**Notification of a Decision taken by the Cabinet Member for
Regeneration, Environment and Housing**

Subject: Proposed waiting restrictions borough wide 2018 Batch 1 (statutory consultation)

Appendix A - Drawing Nos. Z27-660-01 – Z27-660-20

Appendix C – Revised Drawing Nos. Z27-660-03A, Z27-660-06A and Z27-660-14A

Drawing No.	Z27-660-06
Revision	-
Classification	CONSULTATION
Scale	NTS

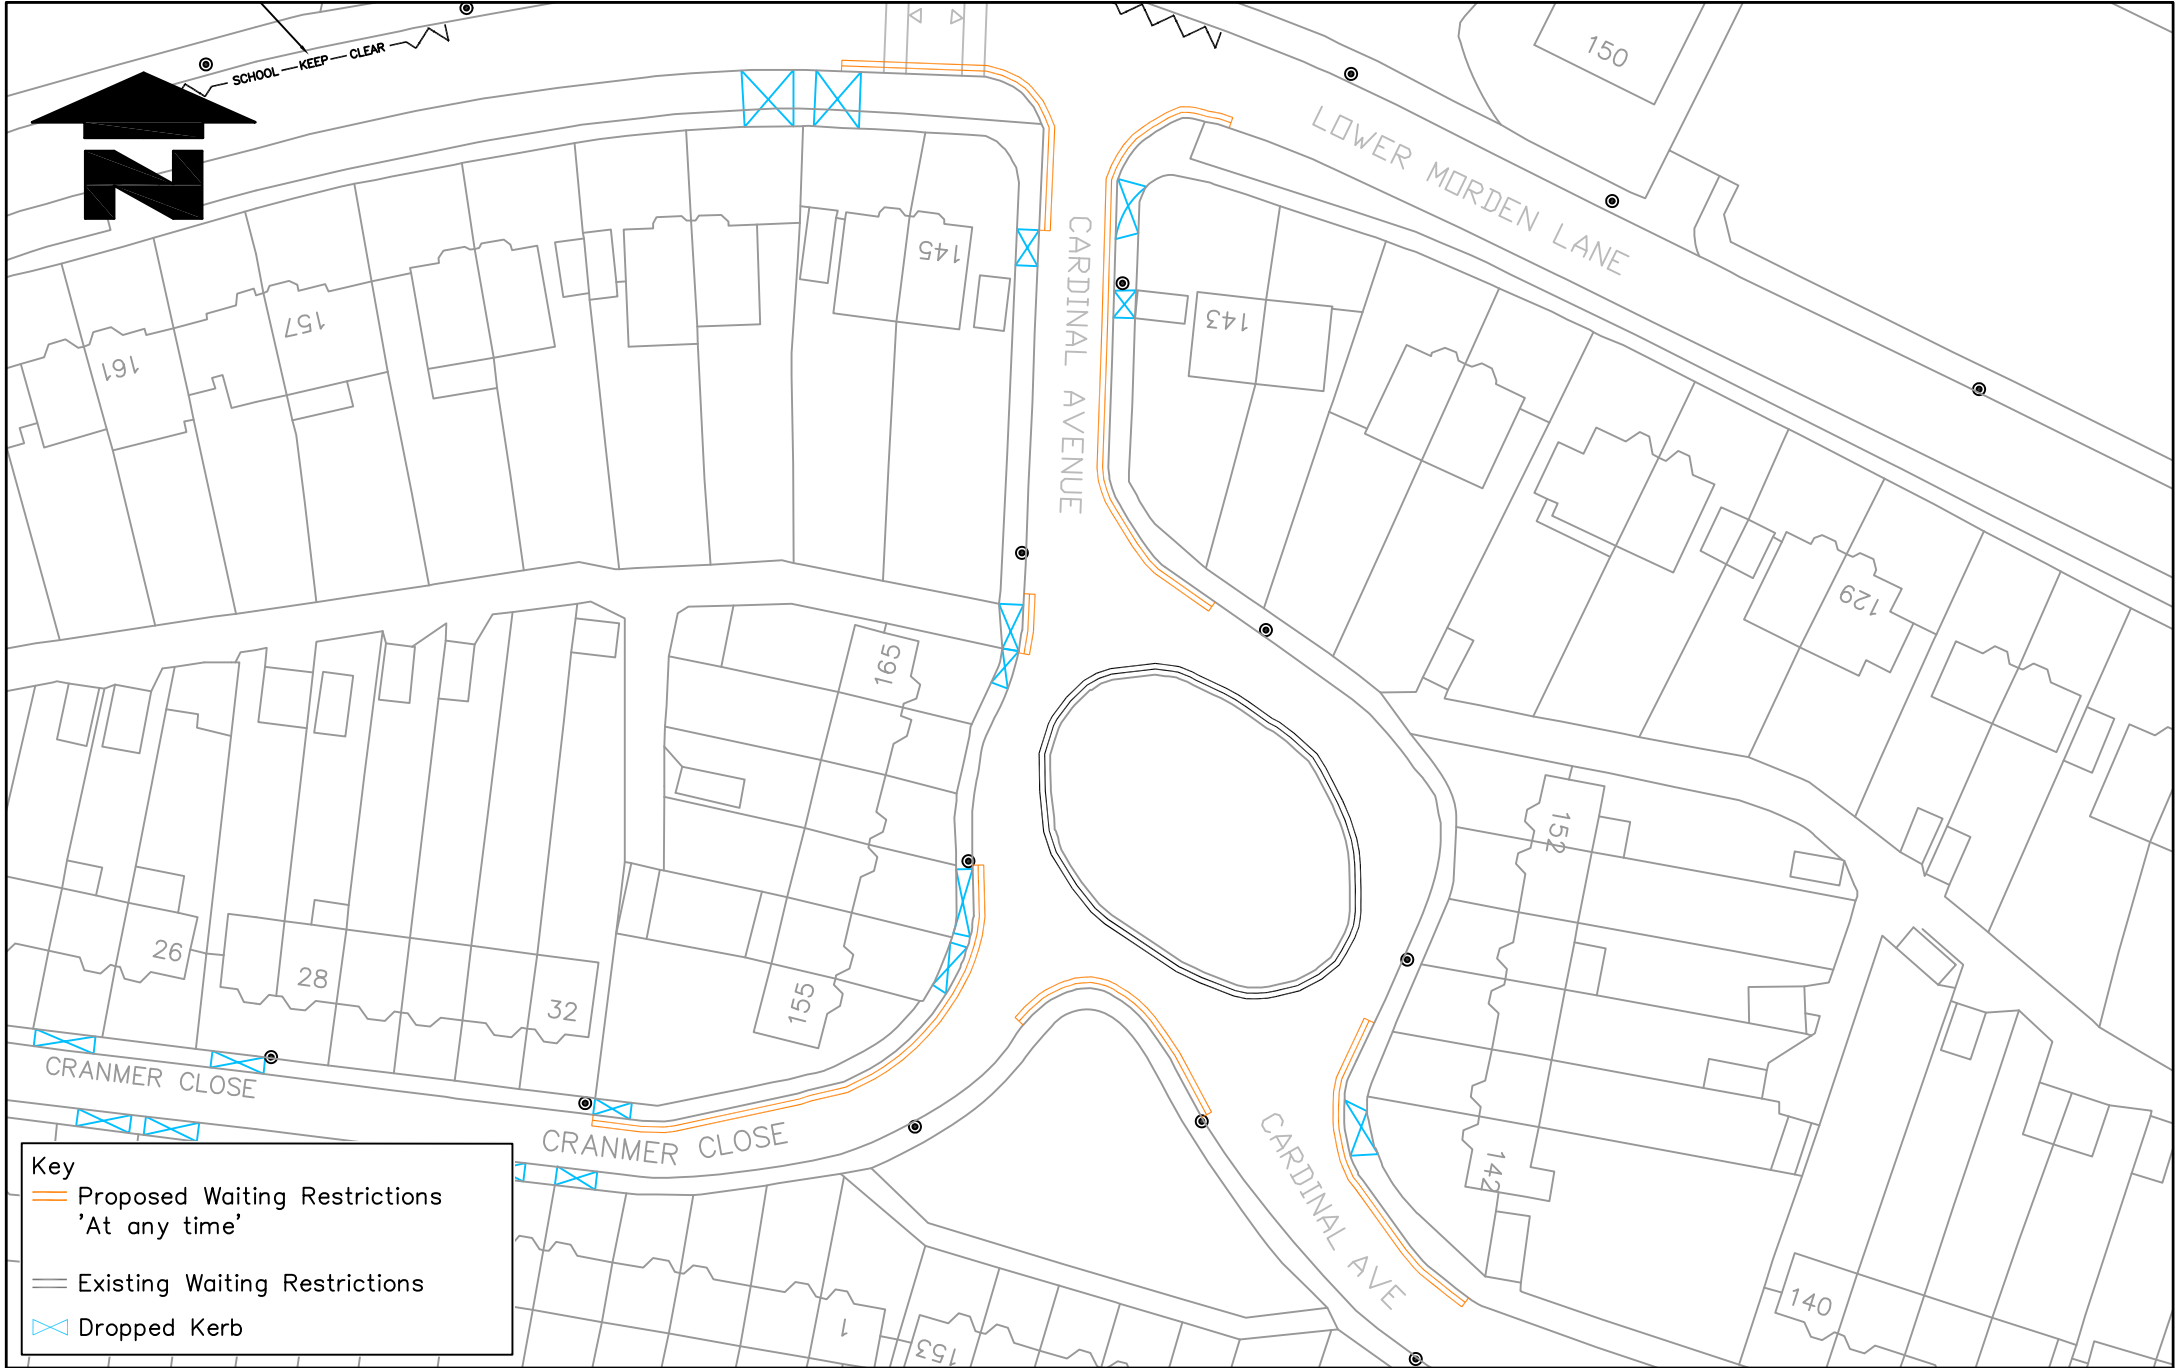
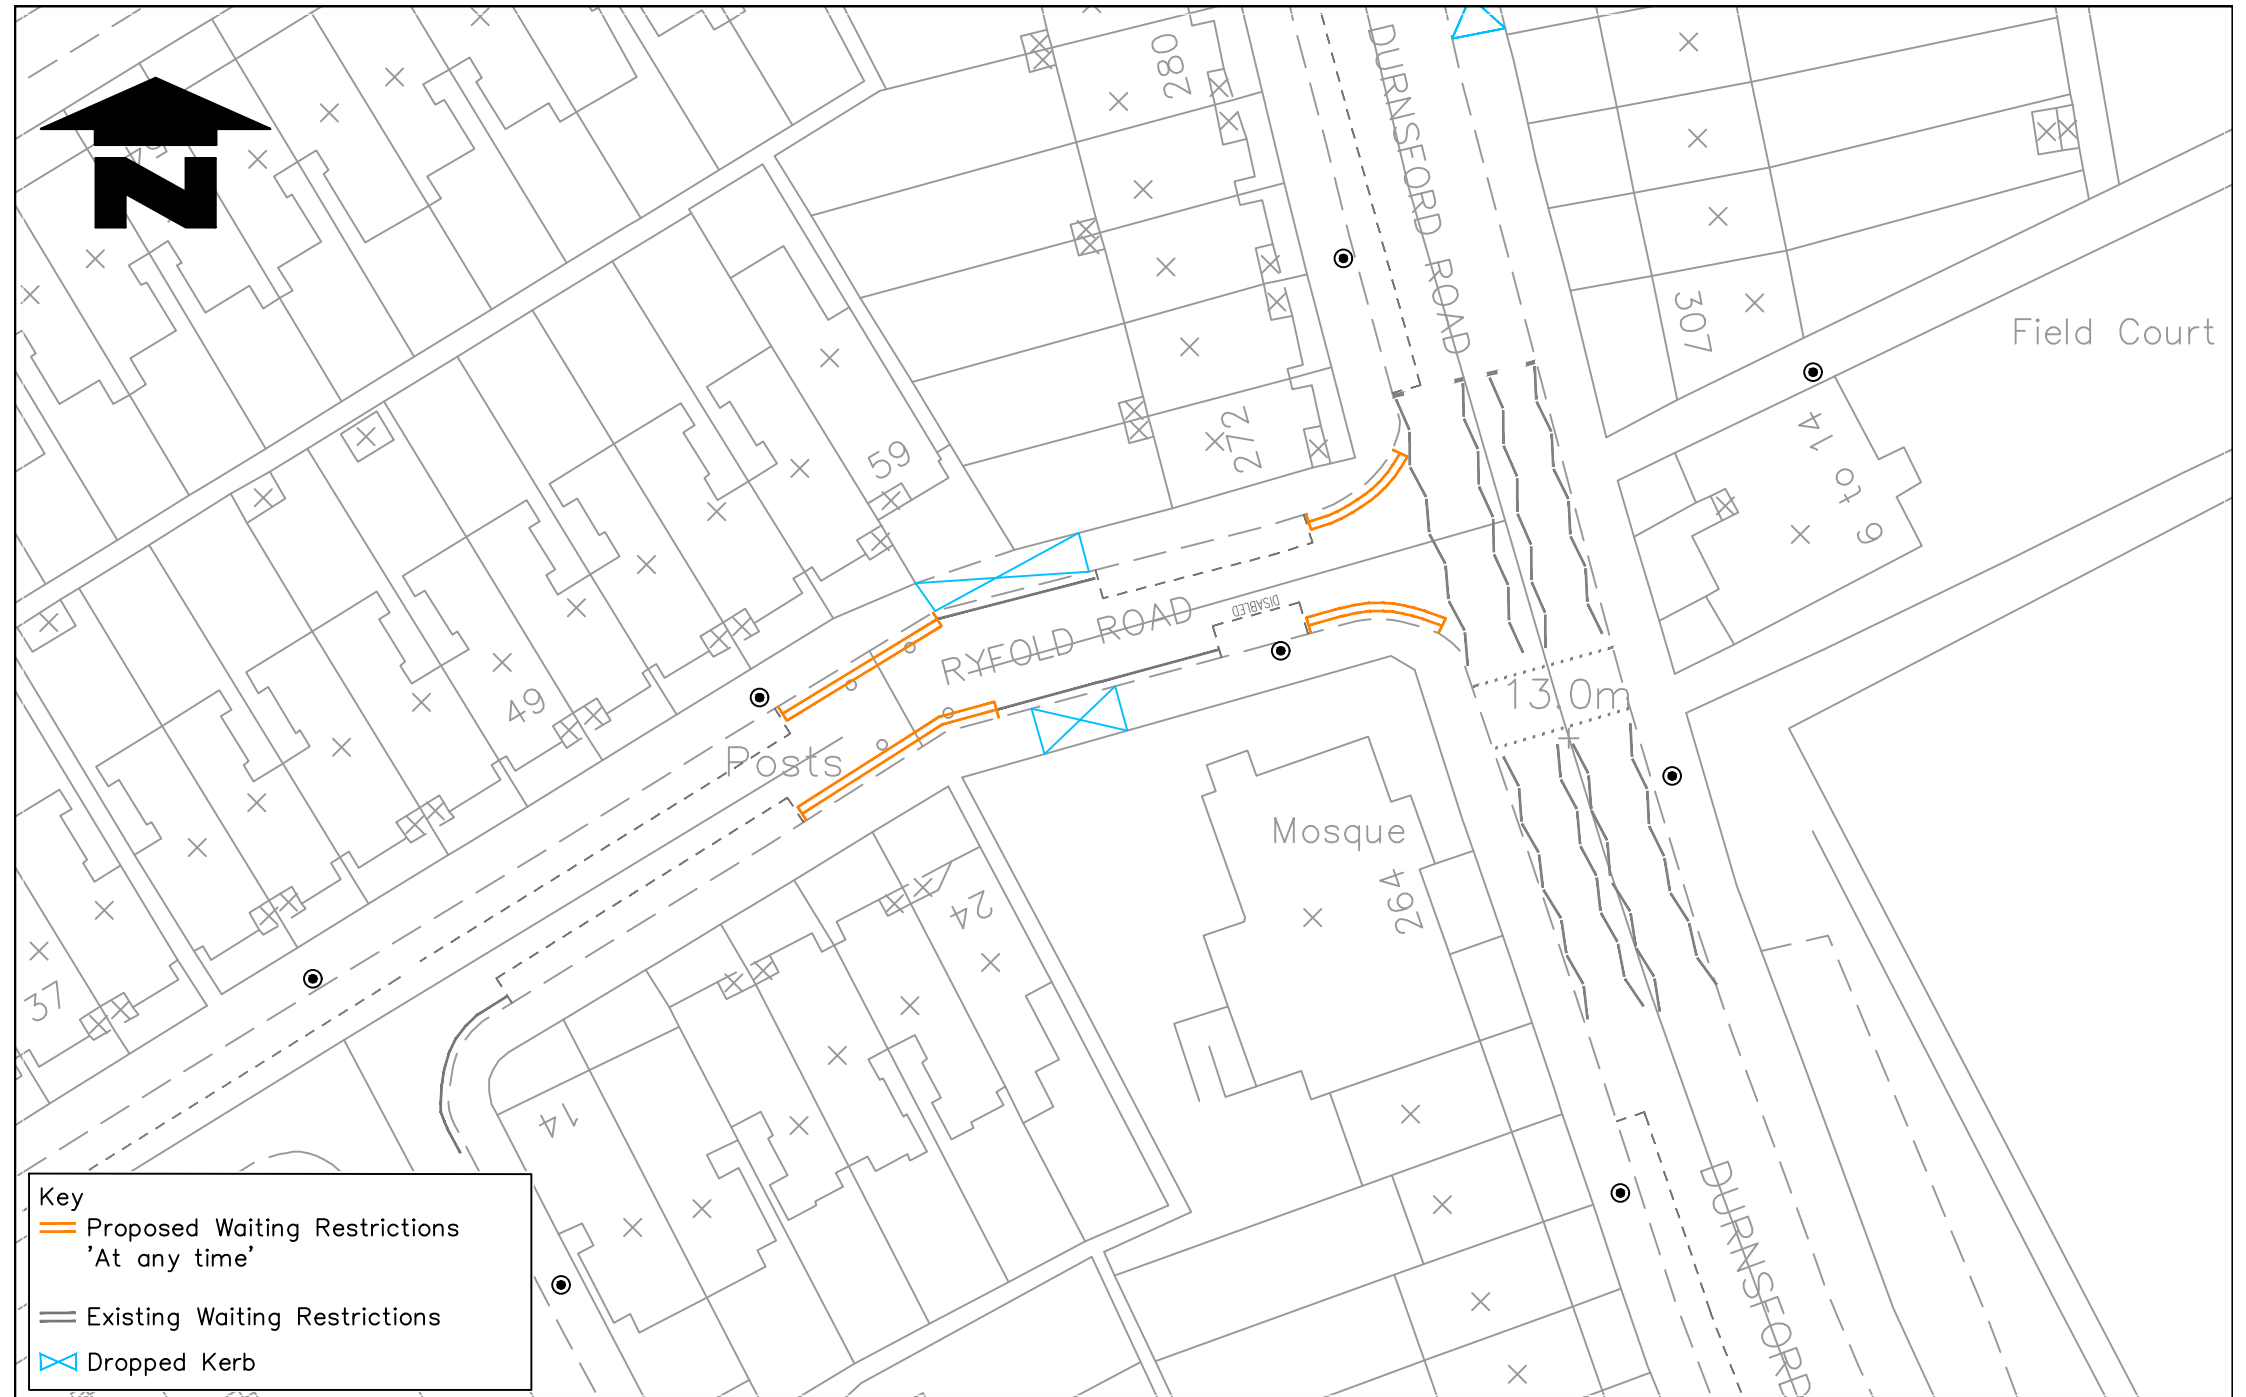
- 4.6 **Berrylands, SW20.** 2 representations in support were received for this proposal.
- 4.7 **Cardinal Avenue and Cranmer Close, SM4.** In response to a resident report of obstructive parking occurring on the bend of Cranmer Close junction with the roundabout and the entrance road of Cardinal Avenue junction with Lower Morden Lane, the proposal also further includes waiting restrictions on the eastern junction of the roundabout into the rest of Cardinal Avenue.

- 4.8 6 representations were received, 5 objecting and 1 in support. The objections were based on the loss of parking in an area already experiencing parking pressure and that the proposed waiting restrictions were overzealous.

Lane junction end at the western boundary of the rear of No 143 Lower Morden Lane. Also that the double yellow lines proposed on the south side of the Cranmer Close/Cardinal Avenue junction be removed completely. These lines appear on drawing Z27-660-06 but I can't find a reference in the Public Notice Schedules. The junctions here are wide with no oncoming traffic and would free useful parking spaces.

Your drawing Z27-660-06 showing drop kerbs around the roundabout in Cardinal Avenue is hopelessly out of date. It shows drop kerbs at the following properties:- 157-159-165 Cardinal plus the entrance to the alleyway behind 165. On the other side of the roundabout it shows 142 as having a drop kerb. The properties that actually have drop kerbs are as follows:- Along the right side (looking at your drawing) there are drop kerbs at numbers 142-144-146-148-150-152 plus the entrance to the alleyway behind 152. In Cardinal Avenue itself you show no drop kerbs at all. In actual fact there are drop kerbs at numbers 141-137-135-133-131.

- 4.9 Giving consideration to the representations the extents of the proposed waiting restrictions are to be reduced to address specifically the reported locations only affected by obstructive parking. The revised proposal can be found in appendix C.

Langdon Road SM4

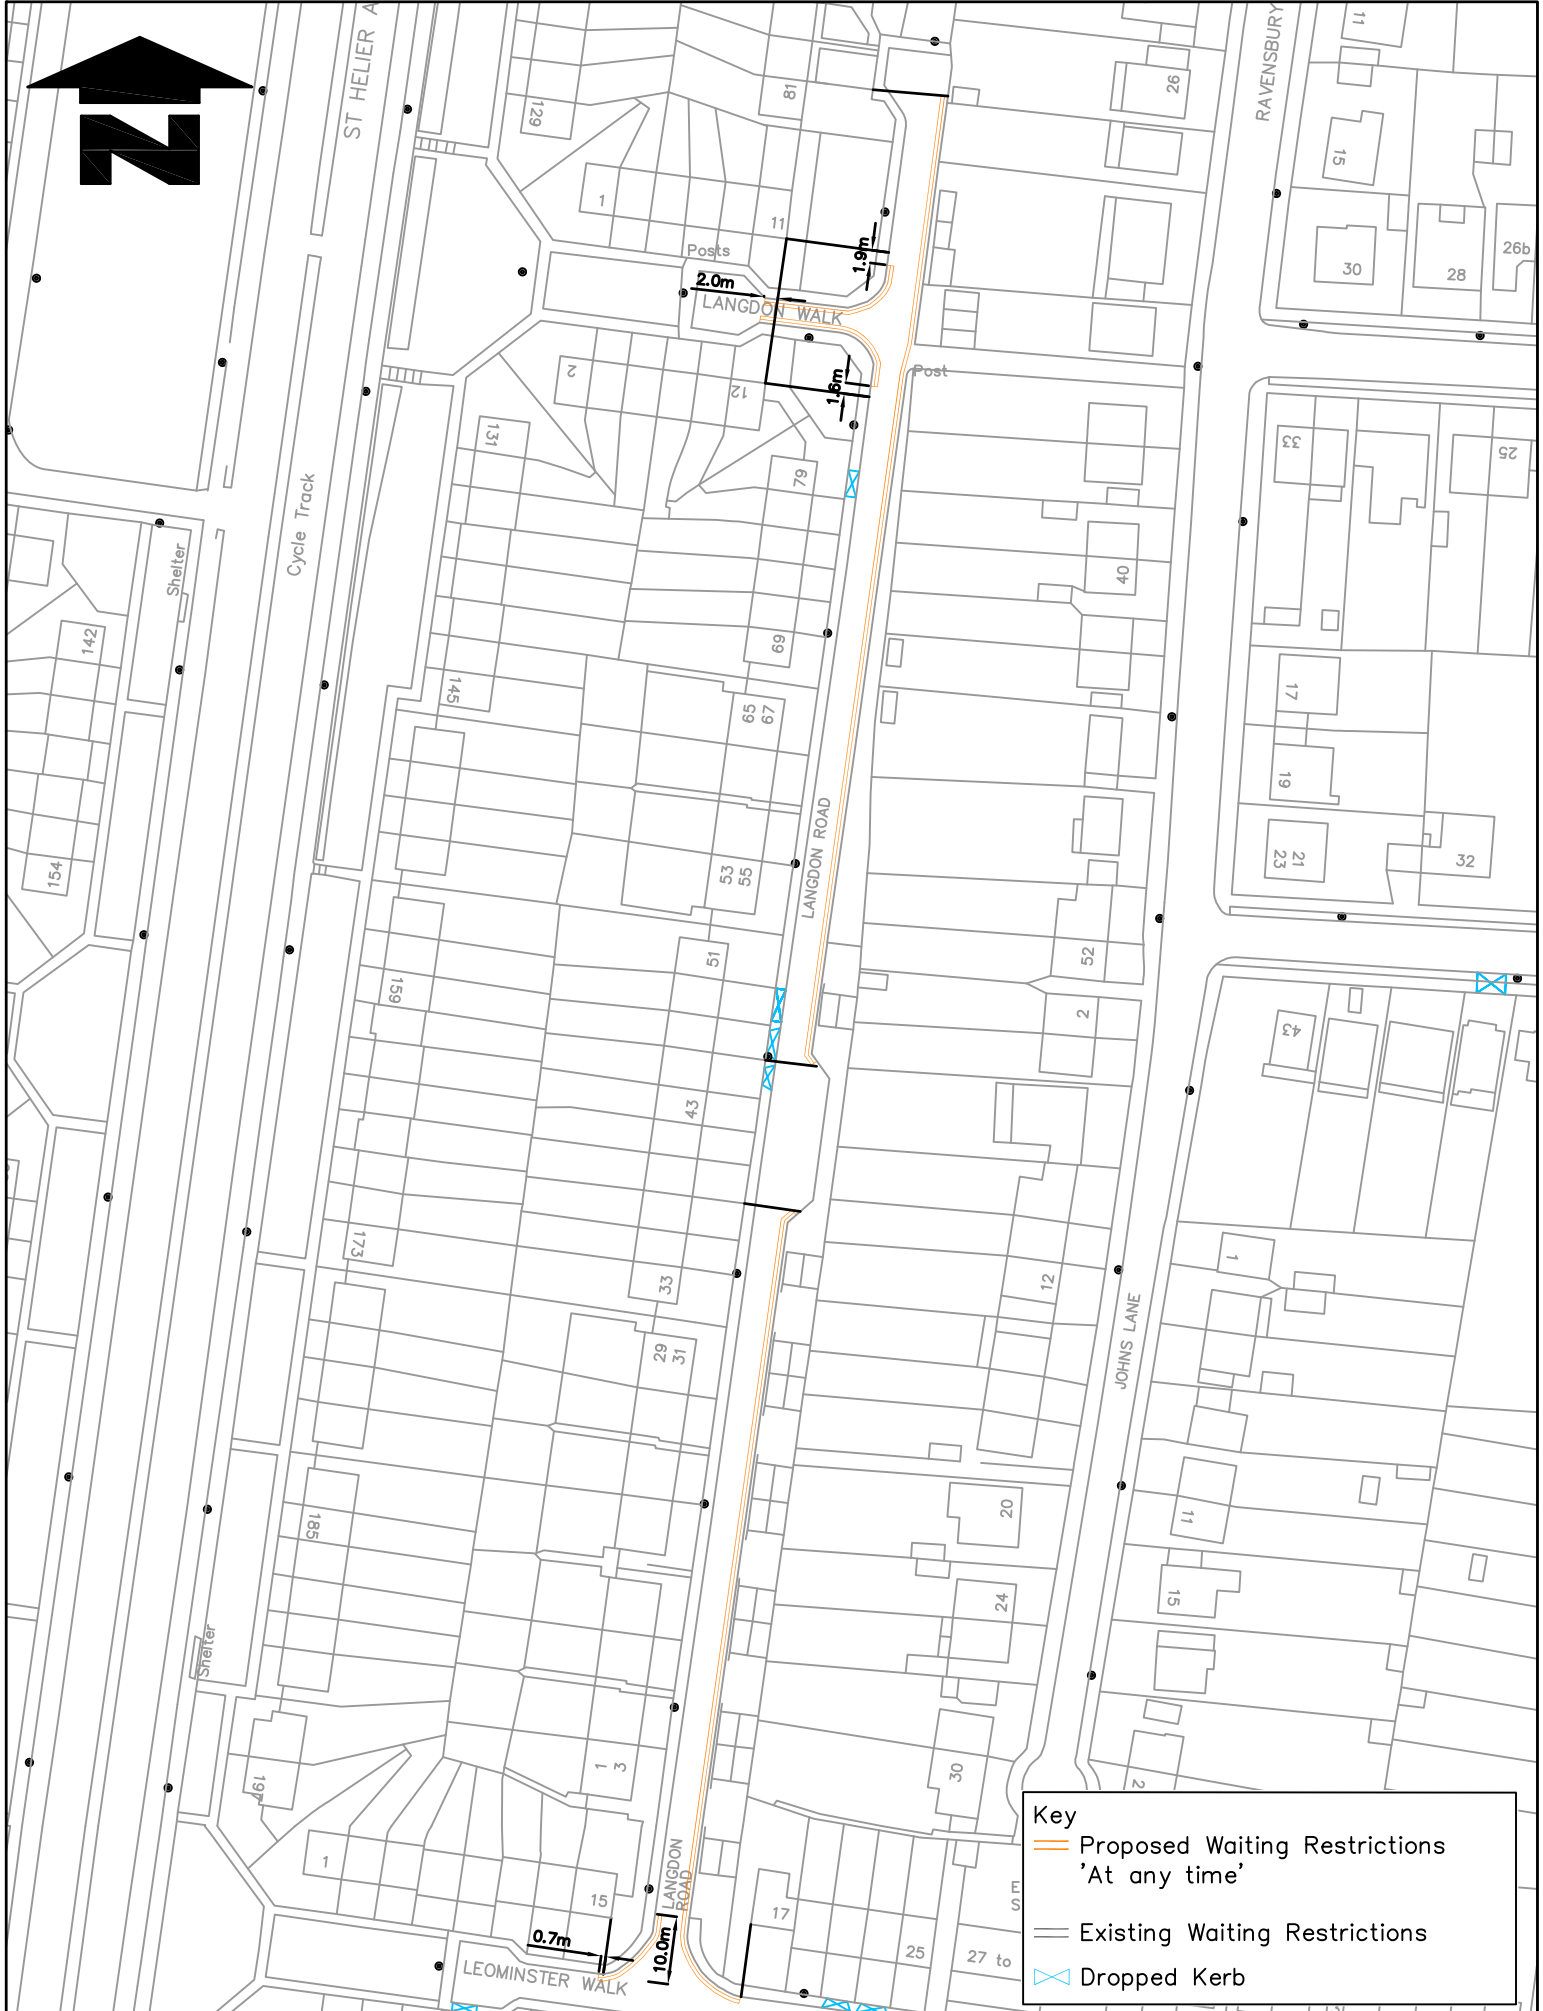
- 4.13 **Langdon Road, SM4.** Response to a request from Safer Neighbourhoods Team to introduce waiting restrictions to Langdon Road, to address obstructive parking, due to frequent call-outs for the team to remove vehicles obstructing moving traffic. A representation of a petition

in objection was received with signatures of 59 residents citing loss of parking space in an area already experiencing parking pressure and devaluation of properties.

- 4.14 It must be noted that the waiting restrictions are only proposed in sections of carriageway where if parking occurs the carriageway would be obstructed and The Council has a statutory duty to ensure safety and access for moving traffic on the public highway, especially refuse vehicles and emergency service vehicles and this takes priority over loss of parking. The restrictions will help to improve safety for all road users and will ensure that access is maintained at all times.
